**APPLICATION FOR PERMISSION  
UNDER SECTION 16 OF  
THE TOWN PLANNING ORDINANCE  
(CAP.131)**

<b>(B) Renewal of Permission for Temporary Use or Development in Rural Areas</b> 位於鄉郊地區臨時用途/發展的許可續期	
(a) Application number to which the permission relates 與許可有關的申請編號	A/ <u>YL-LFS</u> / <u>345</u>

Proposed Temporary Public Vehicle Park  
for Private Cars and Light Goods Vehicles  
for a Period of 3 Years Lots 2888 RP (Part)  
and 2889 RP (Part) in D.D. 129, Sha Kong  
Wai, Yuen Long, N.T.

**Government Departments' General Comments**

As-built  
Drainage  
Plan

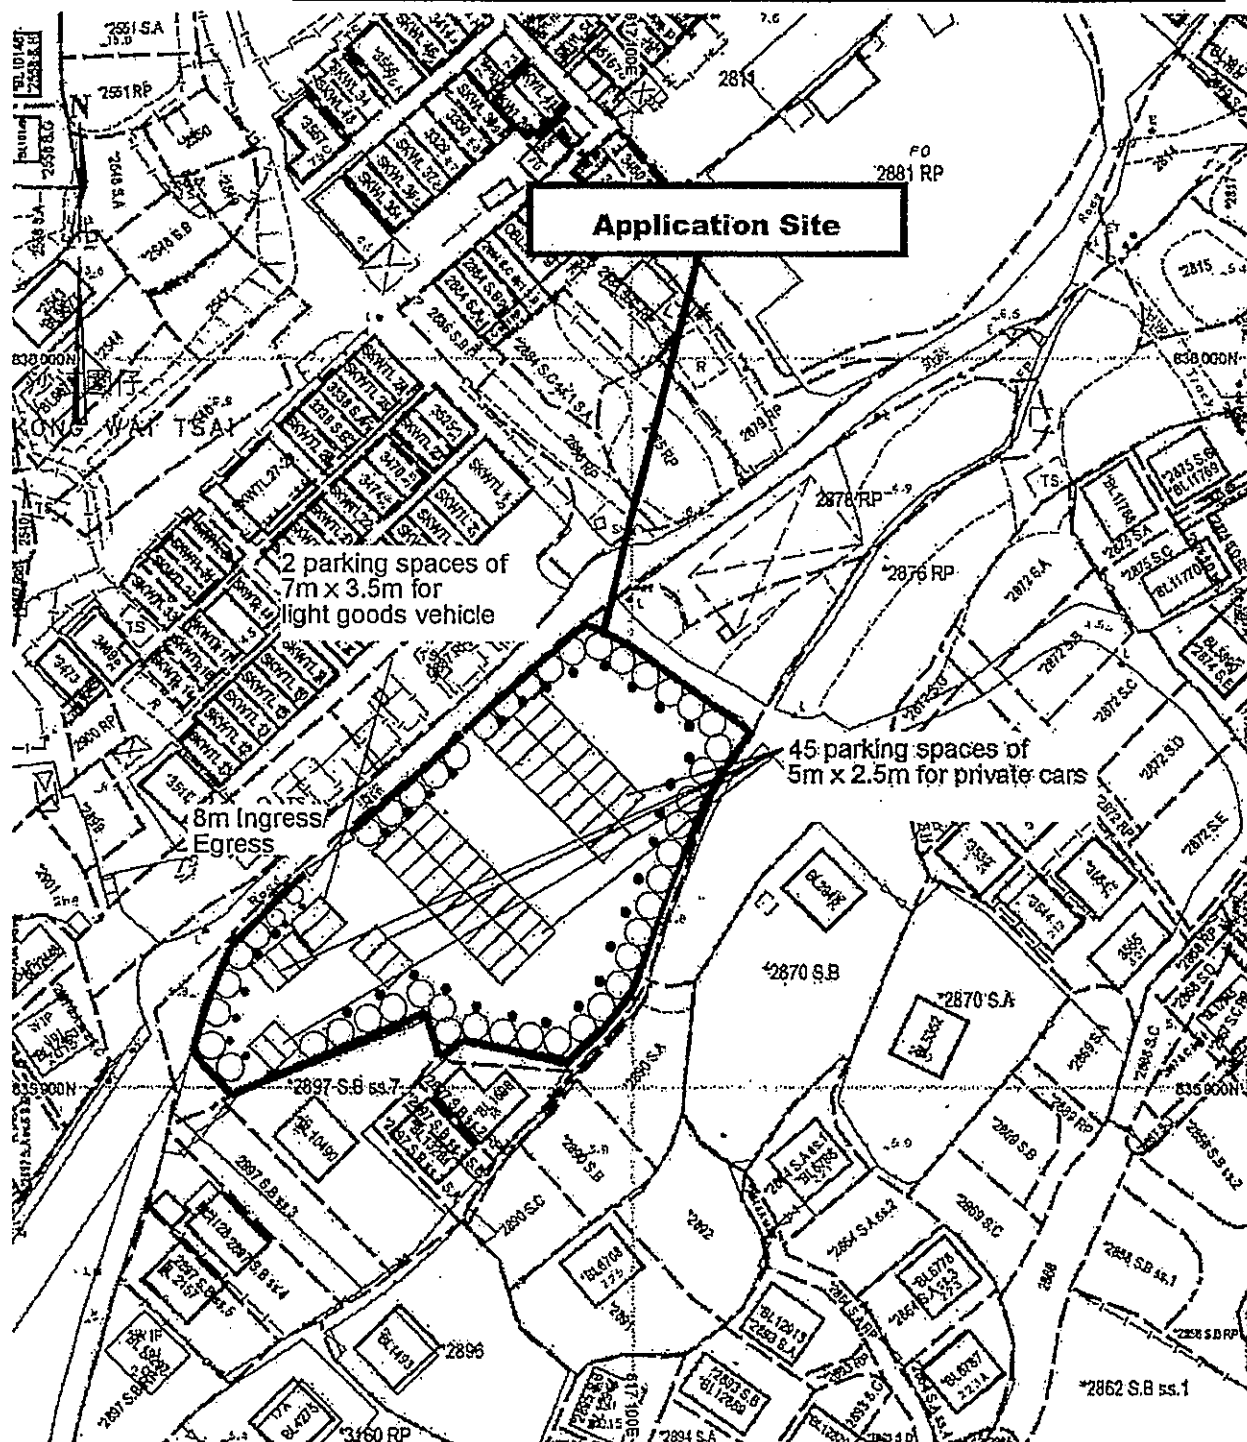
- (a) According to the applicant's submission, the existing drainage facilities which were implemented under an approved application No. A/YL-LFS/345 will be maintained for the subject development. He has no objection in principle to the application from a drainage point of view.
- (b) Should the Town Planning Board consider that the application is acceptable from planning point of view, he would suggest that a condition should be stipulated in the approval letter requiring the applicant to maintain the existing drainage facilities and submit condition record of the existing drainage facilities to his satisfaction.

- (f) to note the comments of the Chief Engineer/Mainland North, Drainage Services Department (CE/MN, DSD) that the required condition record should include coloured photos showing the current condition of the drainage facilities and a layout plan indicating the locations of the photos taken. The submitted photos should cover all internal surface channels, catch pits, sand traps, manholes, terminal catch pits/manholes and the downstream discharge path as indicated on the submitted drainage proposal;

Location Plan

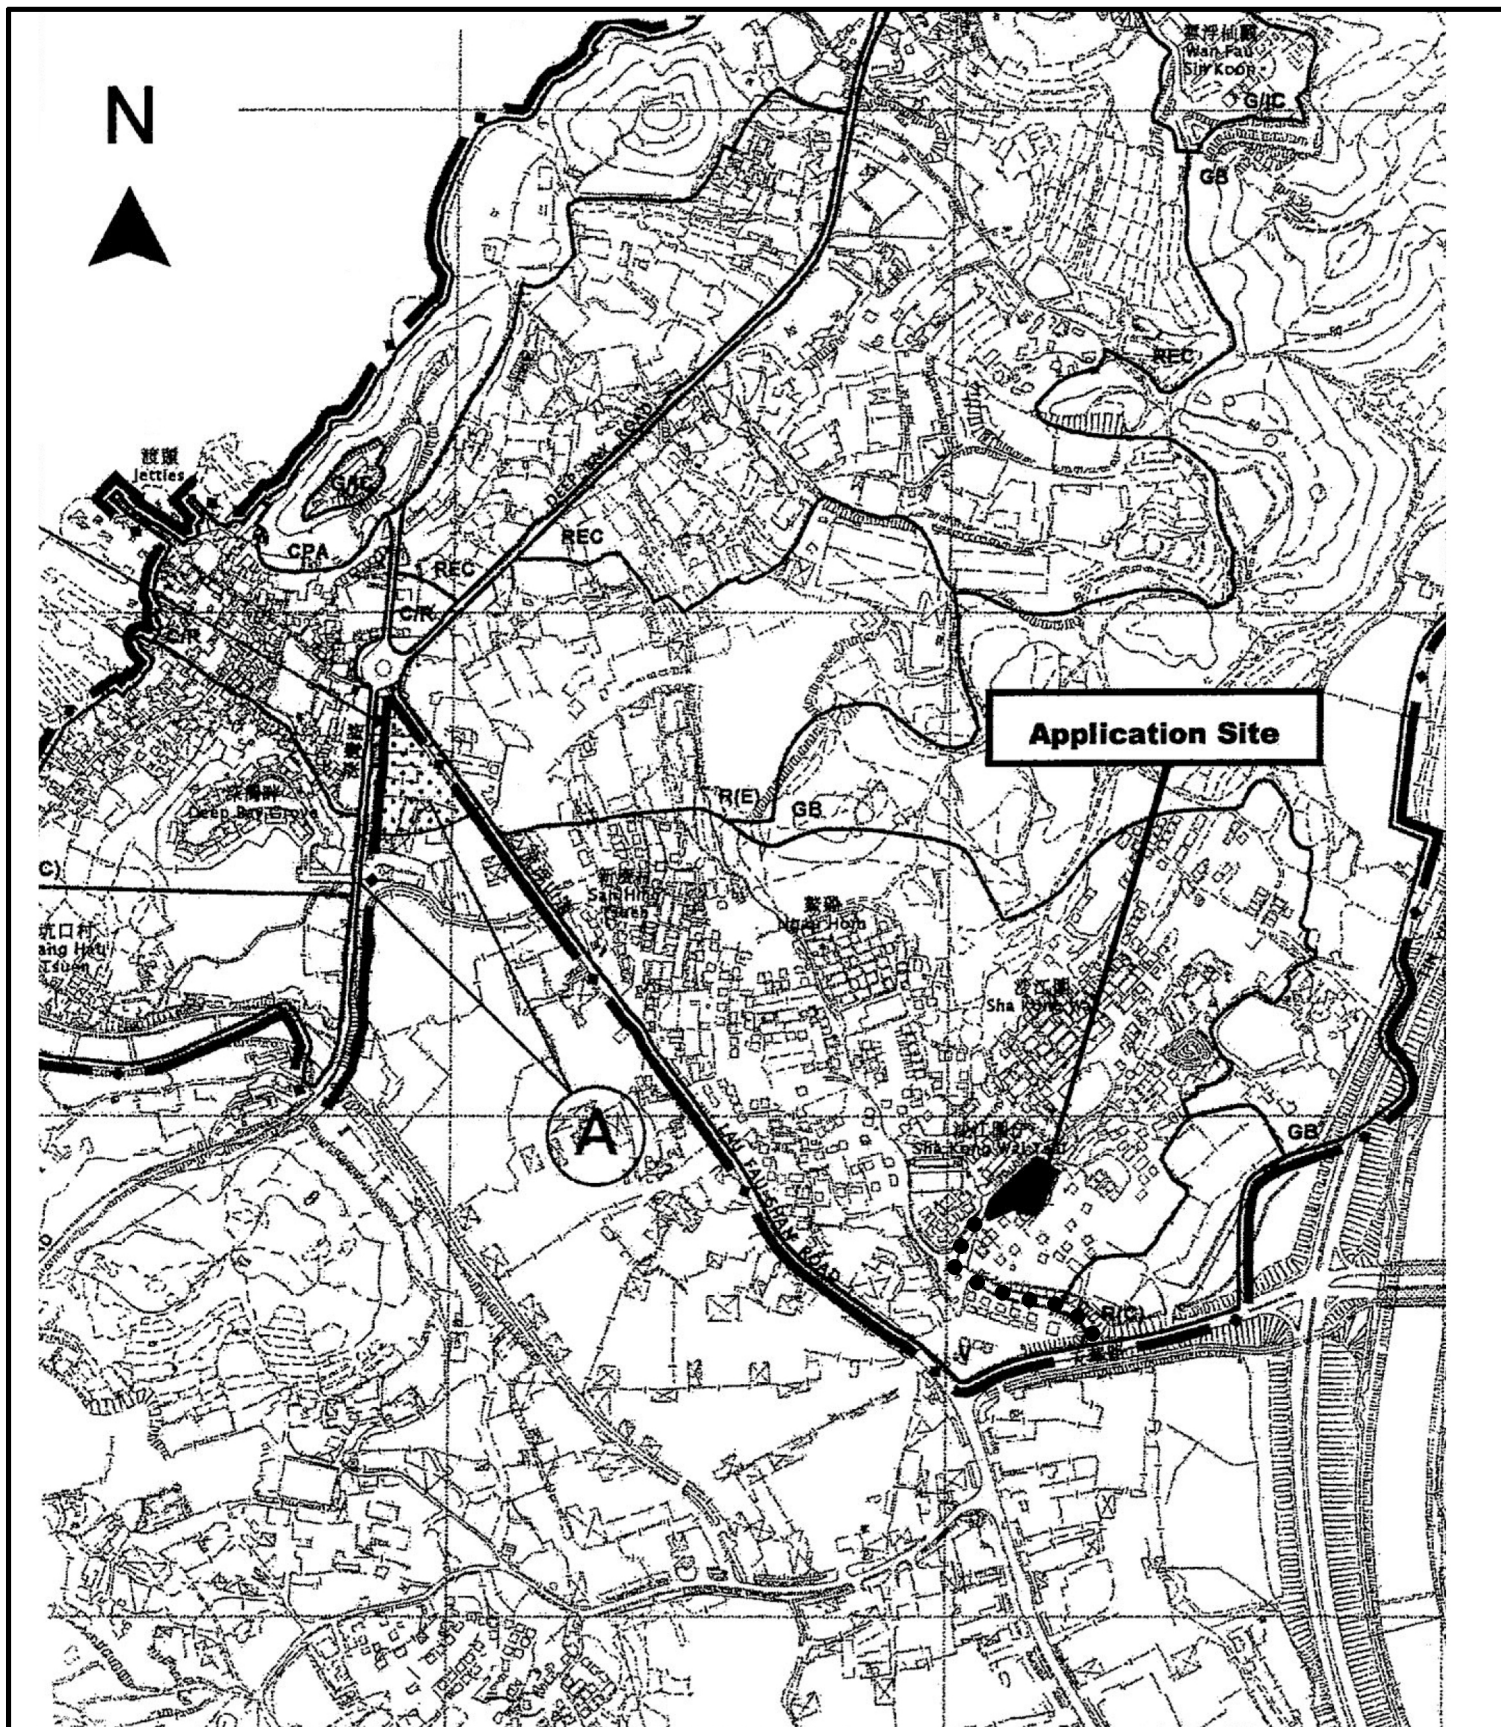
現附上 A/YL-LFS/427 的新的 Location Plan。  
這份圖將取代之前入申請時的Location Plan。  
這個電郵會取代 4:44pm發的電郵。（是錯的）  
請以這個電郵為準。
